STATE OF NORTH CAROLINA  
DEPARTMENT OF TRANSPORTATION

SUBJECT: **Revision Request for Section 404 Regional General Permit No. 31 and Section 401 General Water Quality Certification No. 3886** for the proposed Interstate 85 (I-85) Widening and Interchange Improvements from north of NC 73 (Davidson Highway / Exit 55) to north of SR 2180 (Lane Street/Exit 63), Cabarrus & Rowan Counties, Divisions 9 and 10. Federal Aid Project No. FANHIMF-085-2(61)55, TIP Project No. I-3802A.

Revisions have been made at Sites 7, 7A, 14, and 22. Below are descriptions of the revisions at each of these sites. In addition to this cover letter, please find enclosed revised Wetland and Stream Permit Drawing Sheet Nos. 15 – 20, 41 – 44, 71 – 74, and 126 – 128 of 128; and the revised Mitigation Acceptance Letter from the N.C. Division of Mitigation Services (DMS).

**PERMIT DRAWING**  
**SHEET 18 OF 128**

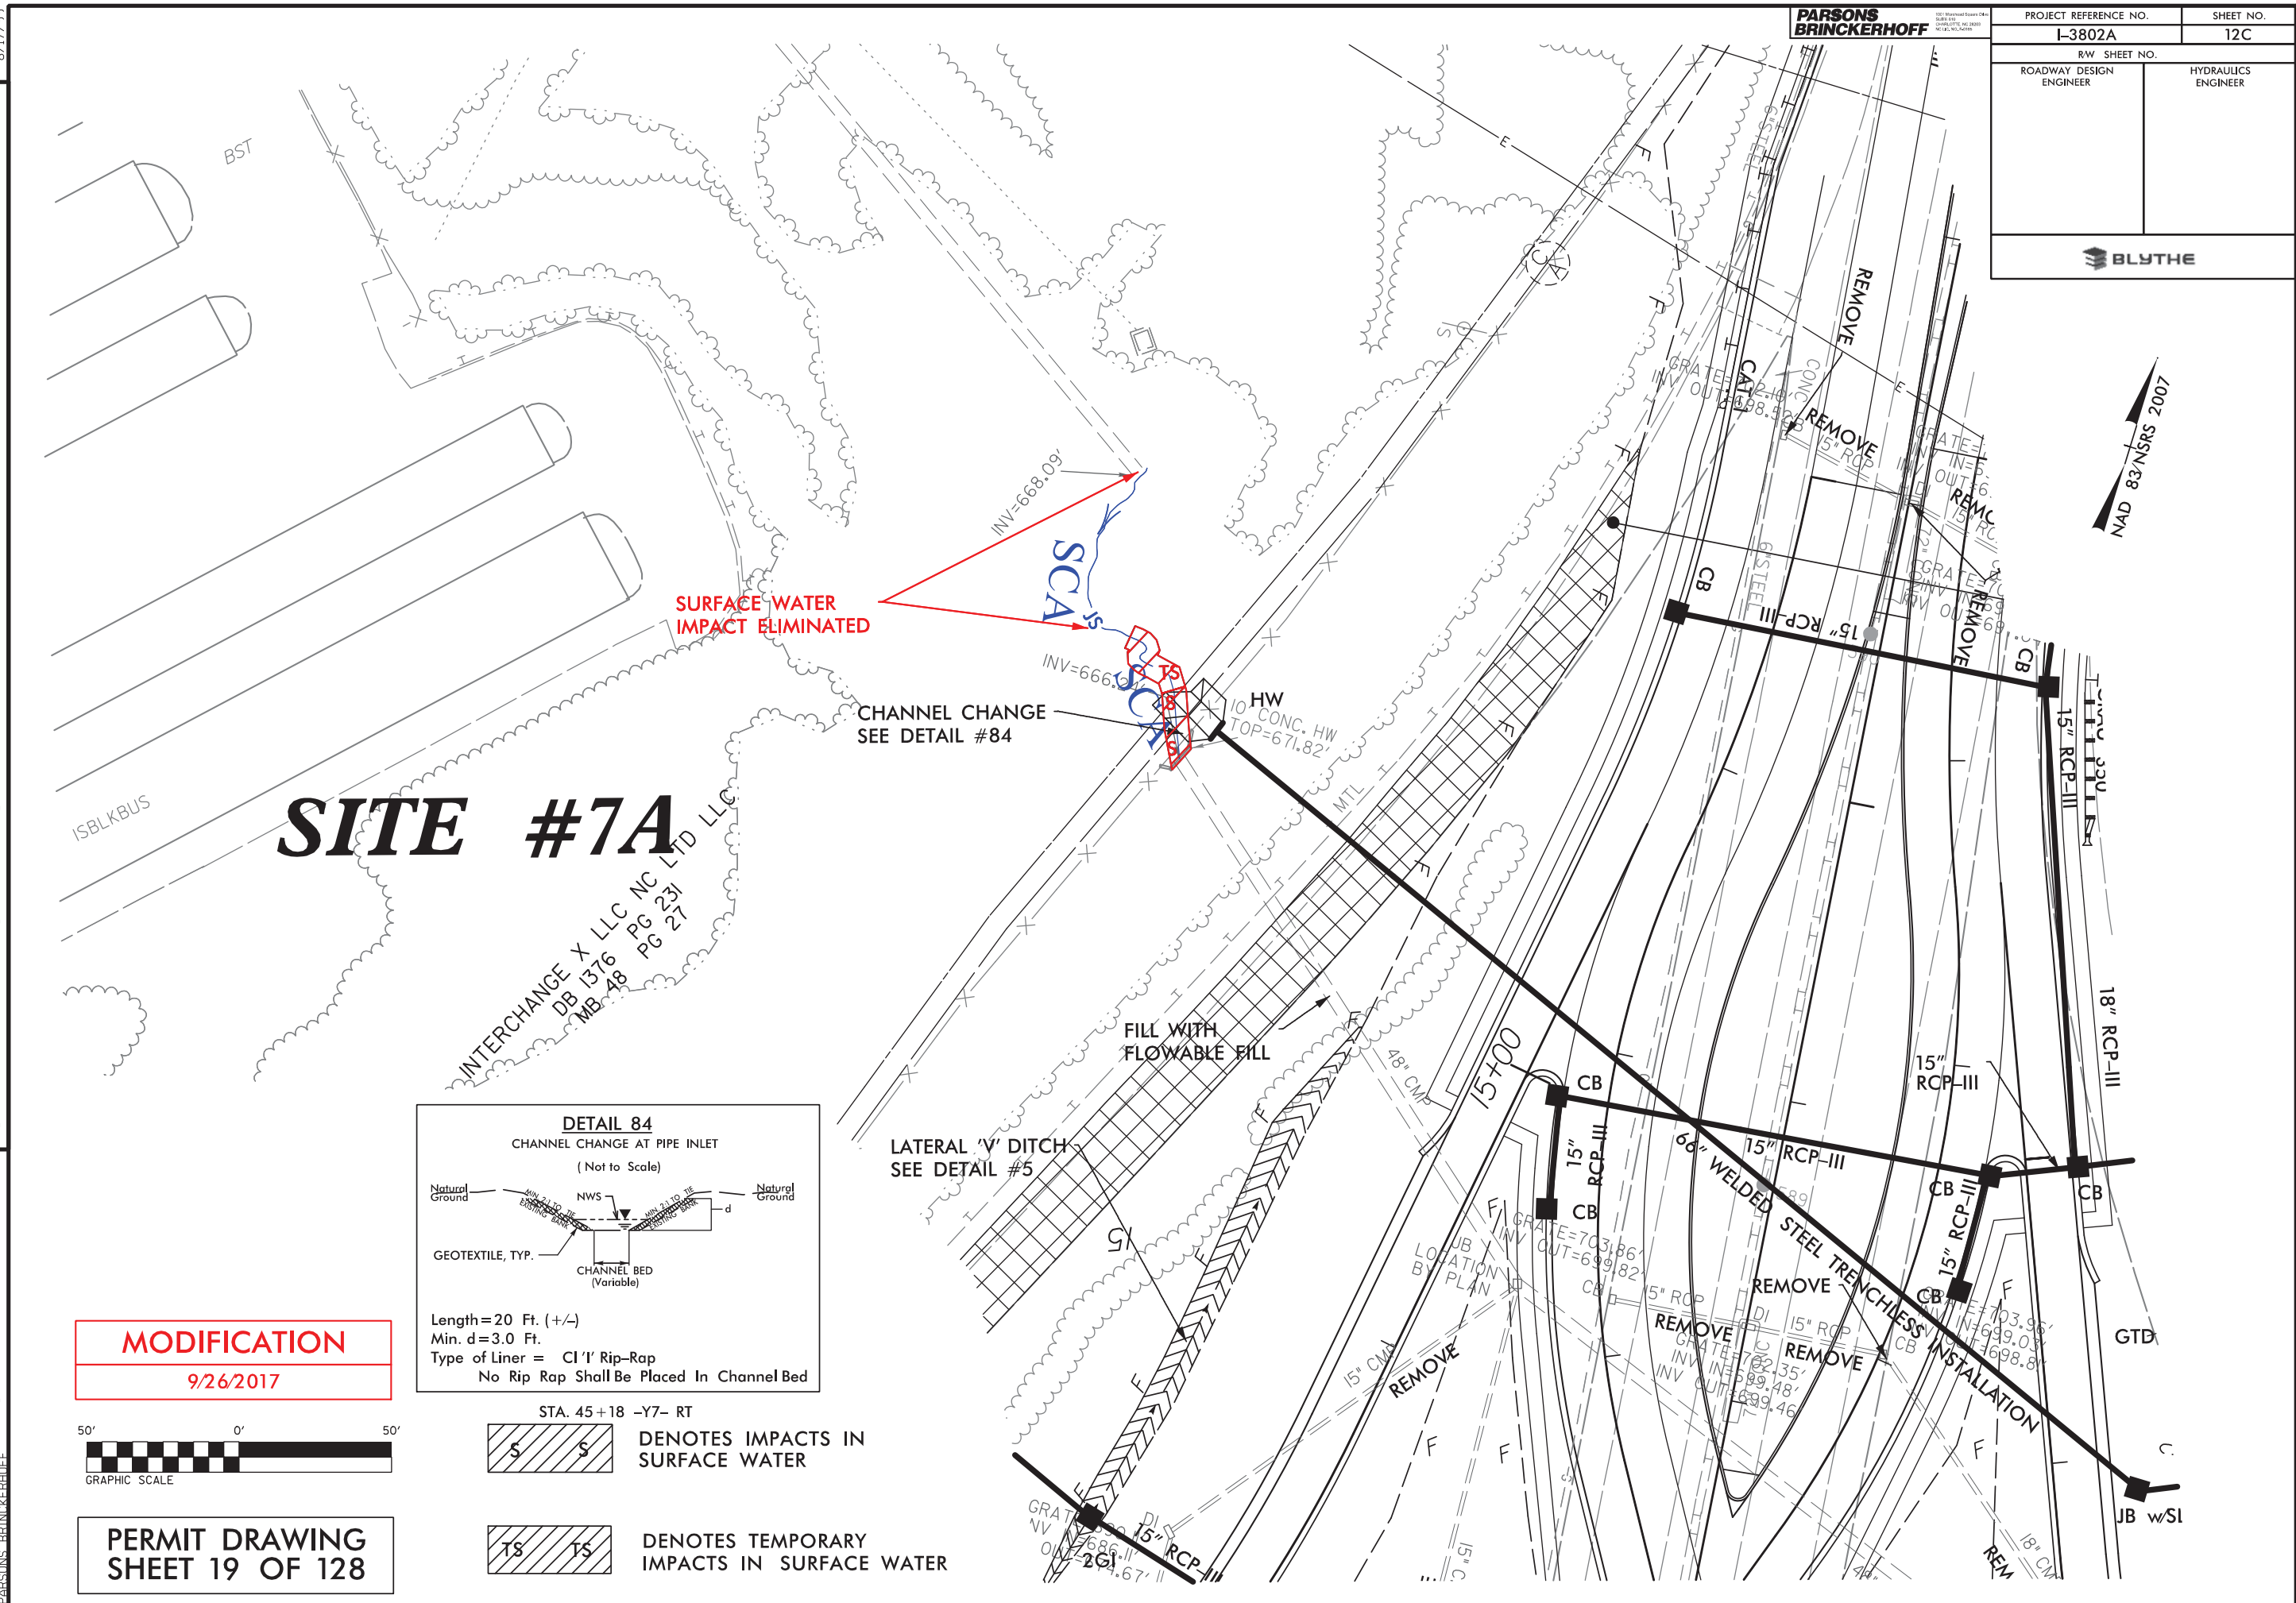
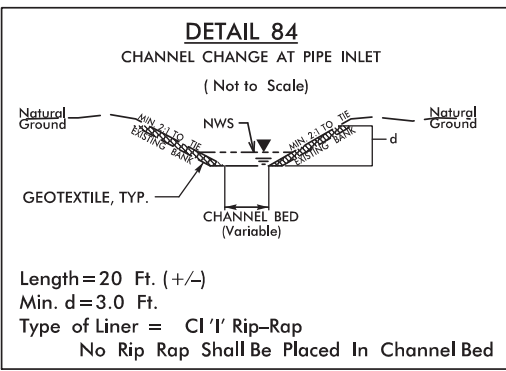
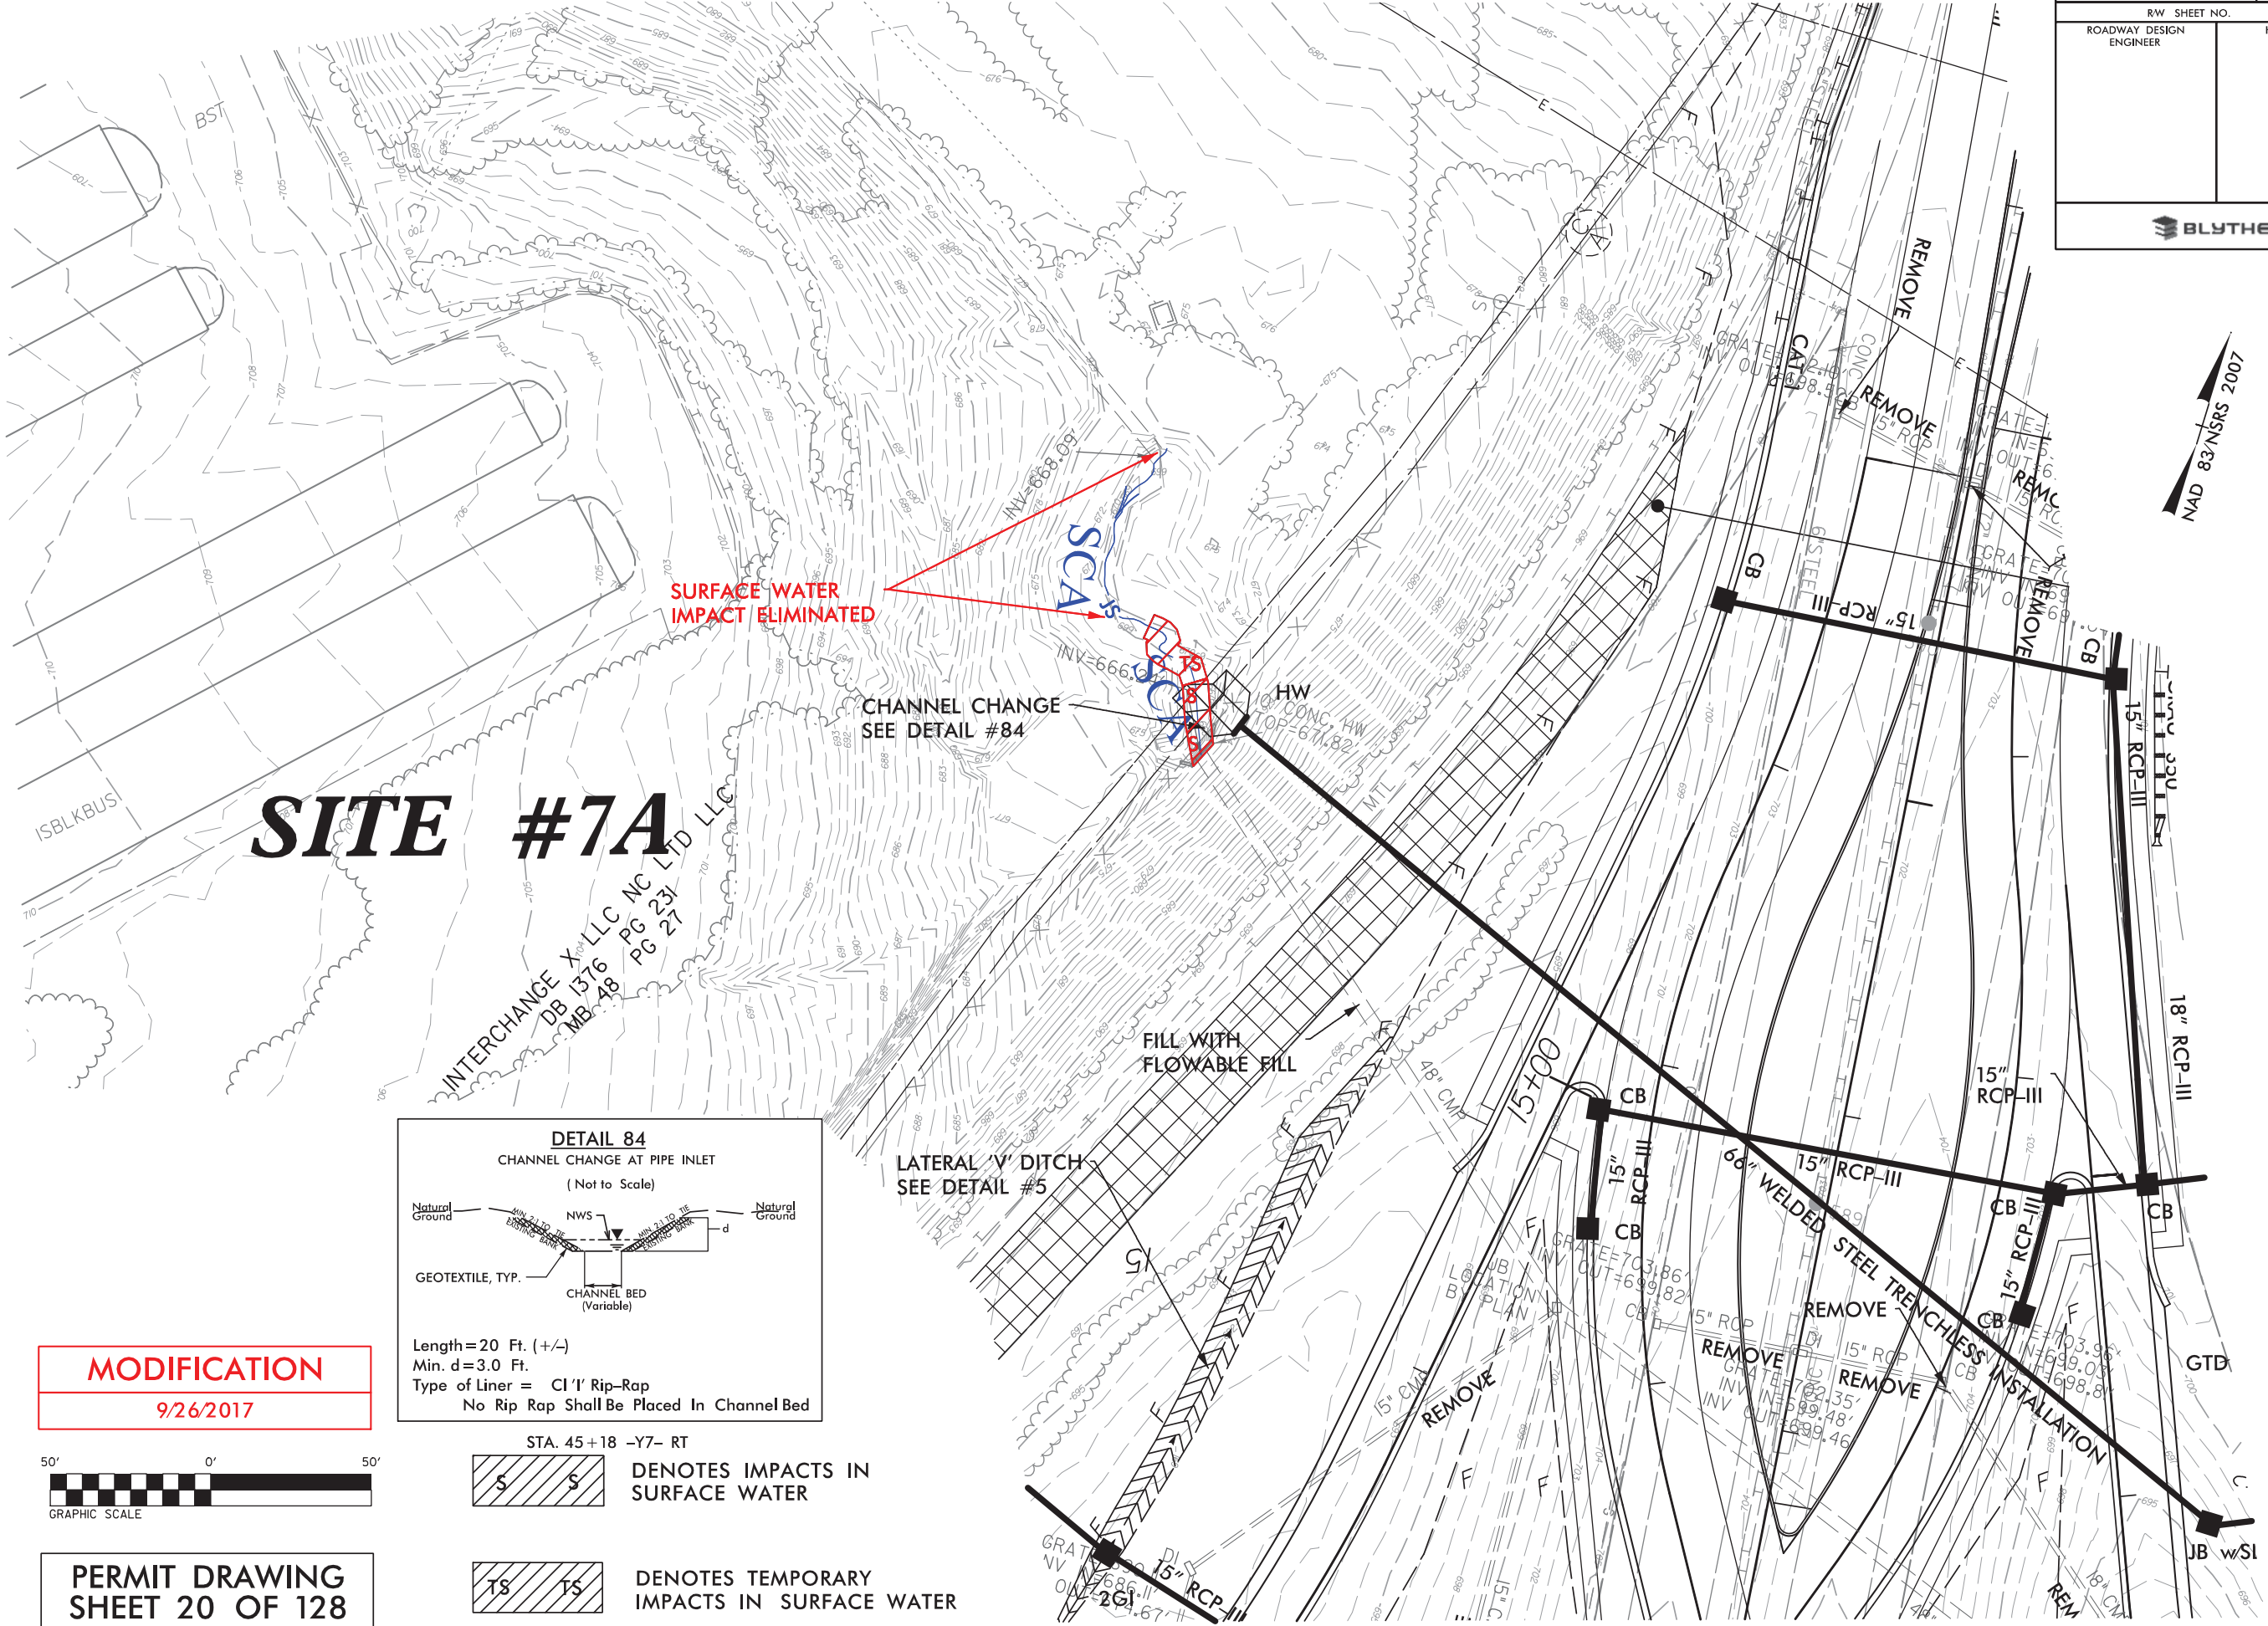
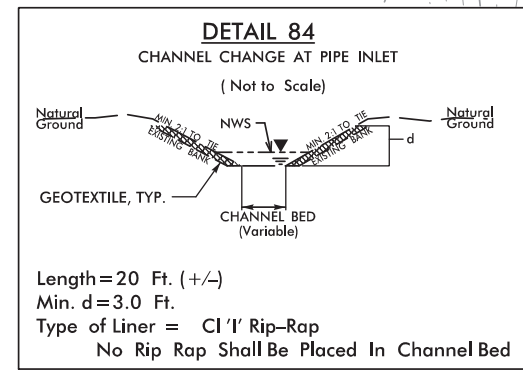
### *Wetland and Stream Permit Site 7A (Stream SCA)*

Permanent surface water impacts were reduced from 120 linear feet to 23 linear feet, which is a reduction of 97 linear feet. Additionally, 24 linear feet of temporary stream impact was added to the site; previously, no temporary impacts occurred at this site.

**SURFACE WATER  
IMPACT ELIMINATED**
